To: Ken Roberts, City of Lake Elmo Planning Director
From: Lucius Jonett, Wenck Landscape Architect
Date: February 15, 2019
Subject: City of Lake Elmo Landscape Plan Review
Bentley Village Preliminary Plat, Review #1

BENTLEY VILLAGE

LANDSCAPE PLAN - EAST PARCEL

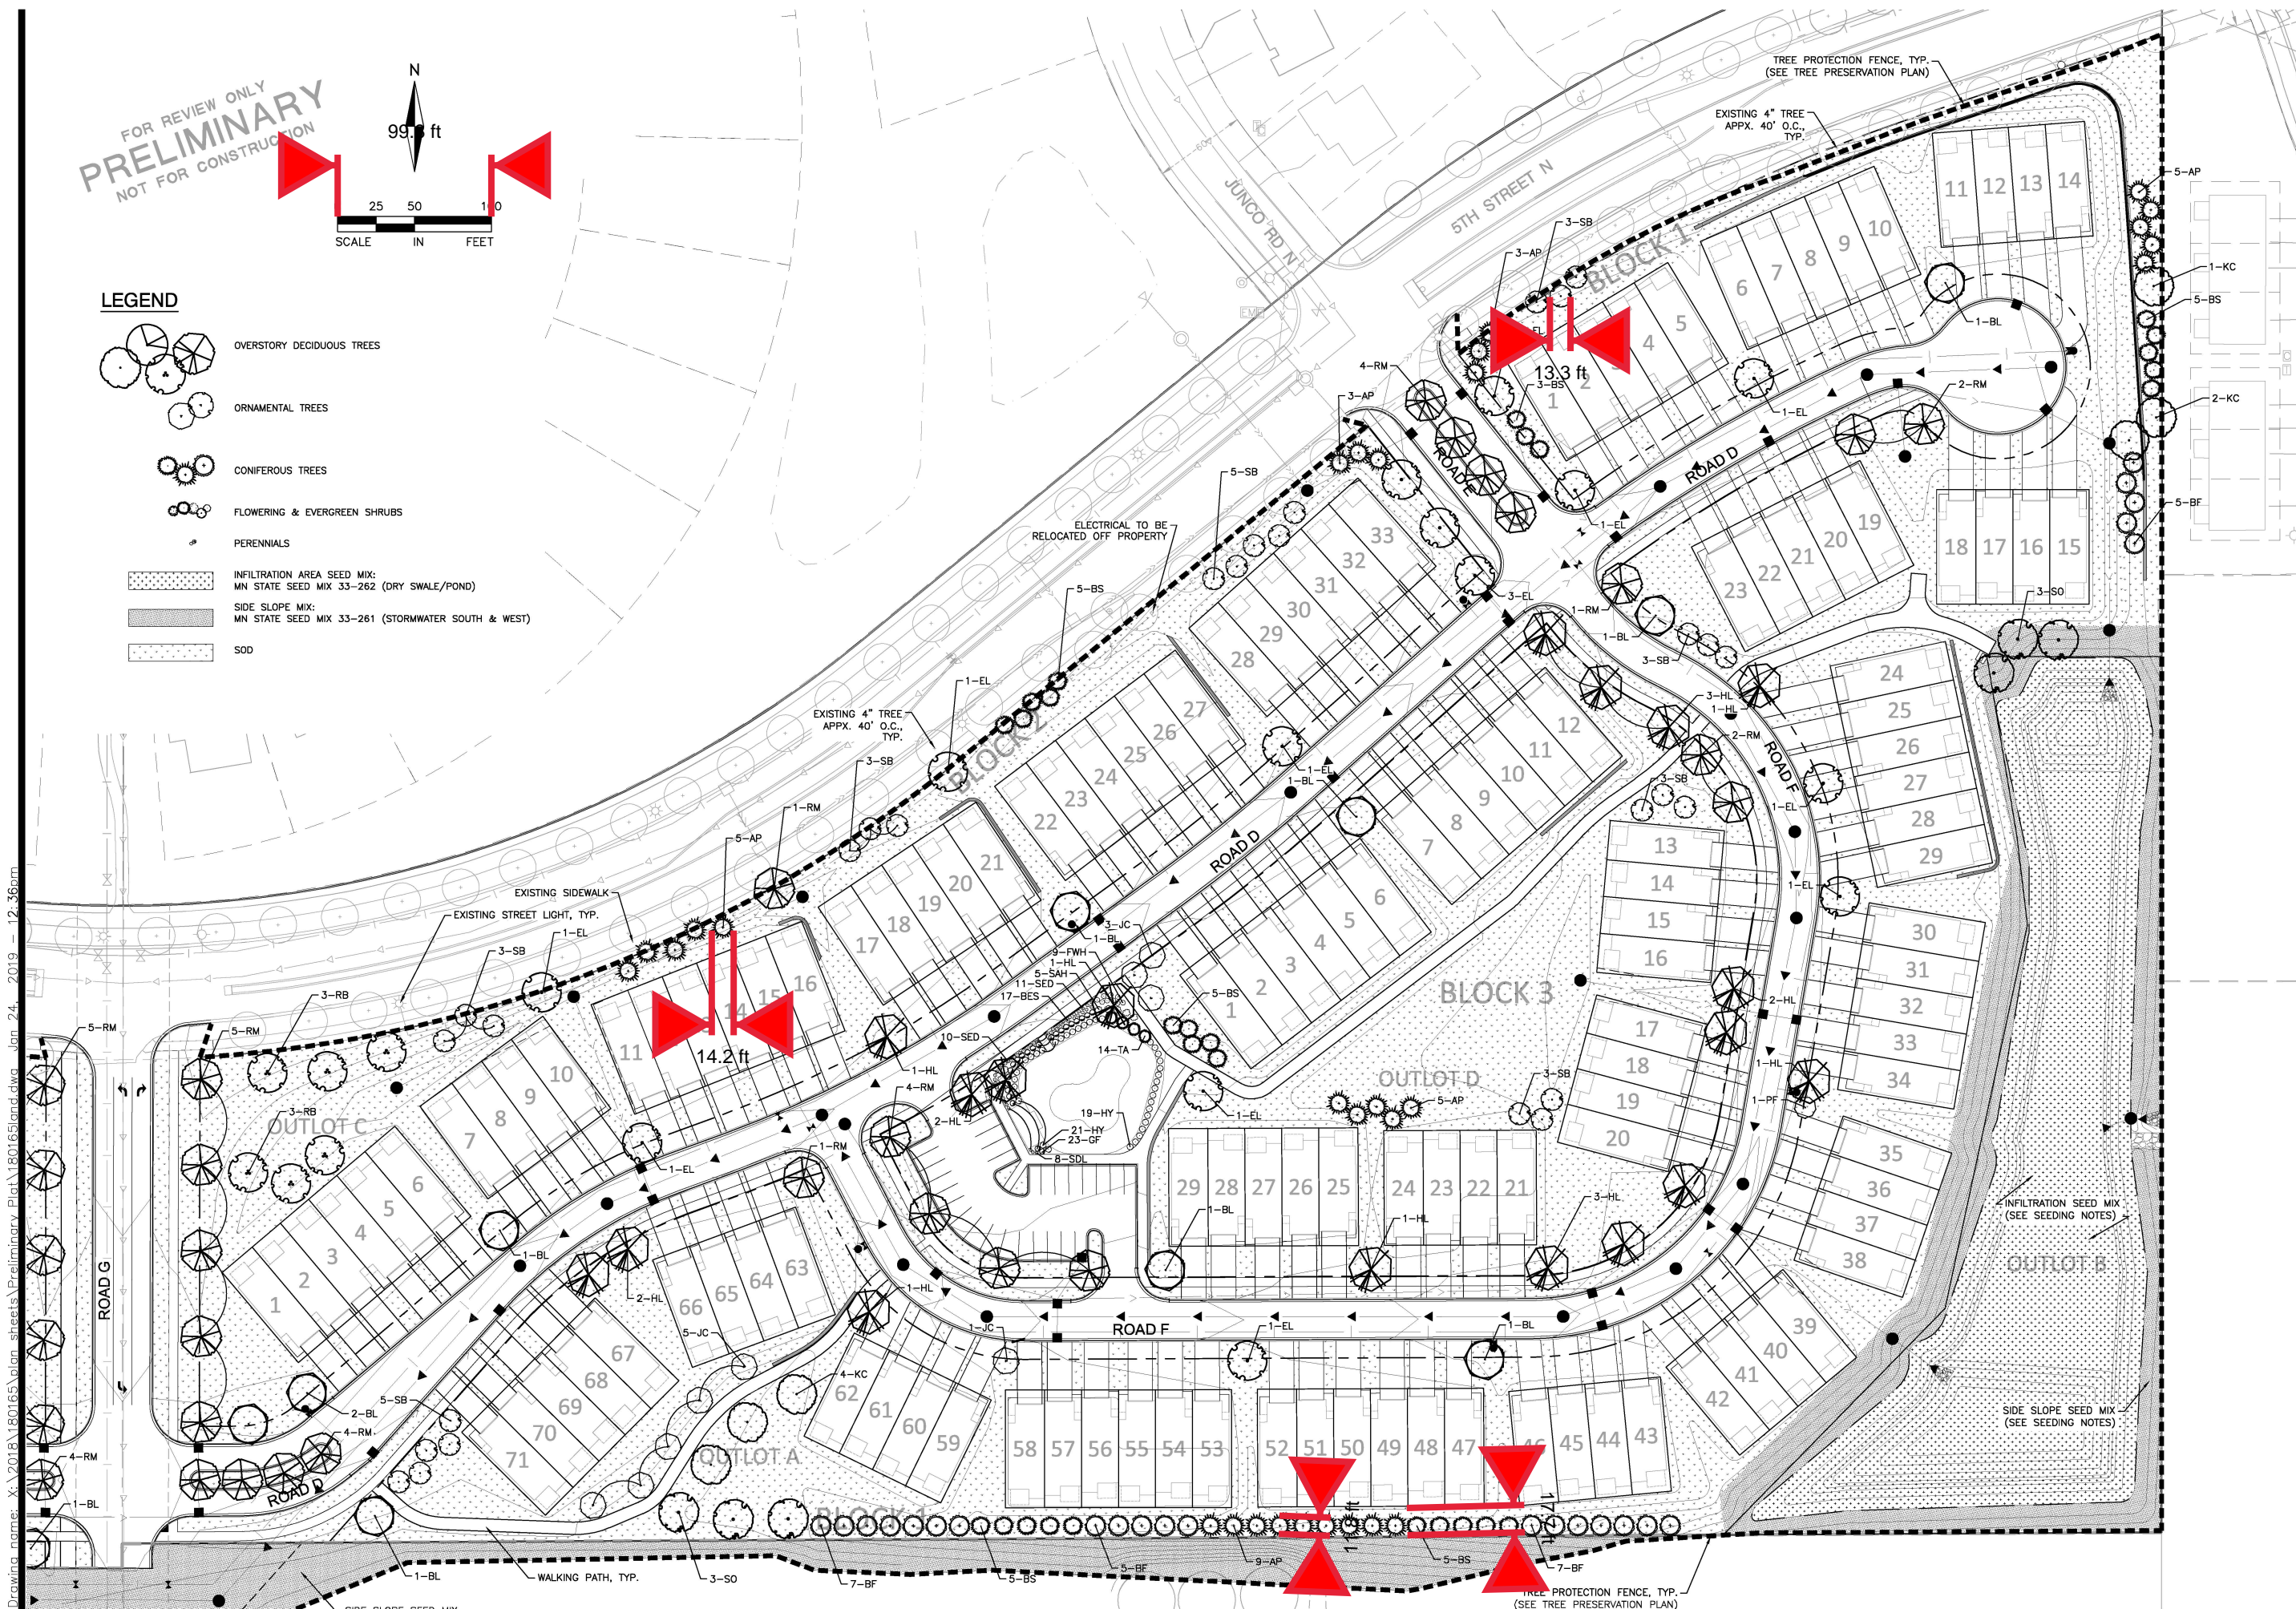
4. Tree symbols are not drawn to full mature size on the proposed landscape plans and should be updated to make sure there is adequate landscape space between property lines and buildings. An example is on the southern property line where the buildings are approximately 18' from the property line. The Austrian pines are drawn at 12' diameter, while their mature diameter is 30' to 40'. There is not enough room for the mature trees

- in this location. Applicant should update the scale of the proposed plantings and make adjustments to the layout (trees or buildings) as required.
5. City standard landscape details and notes have not been used. Applicant should include the City standard landscape notes and details in the drawings and remove their notes that are no longer applicable.

9. A single, straight row of evergreen trees is inadequate for screening as proposed on the West and South property lines. Vegetative screening should consist of more than one row of evergreen trees and include a row of other trees or native shrubs in front of the evergreens to soften the "development wall" effect. The layout of the proposed screening on the East boundary is the minimum acceptable trees for screening and should include native shrubs to provide additional screening depth. The applicant should reconsider the layout of the proposed vegetative screen or consider other screening elements such as masonry wall or fences in combination with landscape material to provide screening.

10. Requiring full screening along the north property line (5th Street) is not recommended as it will interfere with the required boulevard tree plantings in the 5th Street Design Guidelines. The proposed plantings along 5th street are not drawn to mature scale and when updated may require relocation so the trees are not growing into the 5th street boulevard trees or the buildings. Applicant should update the scale of the proposed plantings and make adjustments to the layout (trees or buildings) as required.
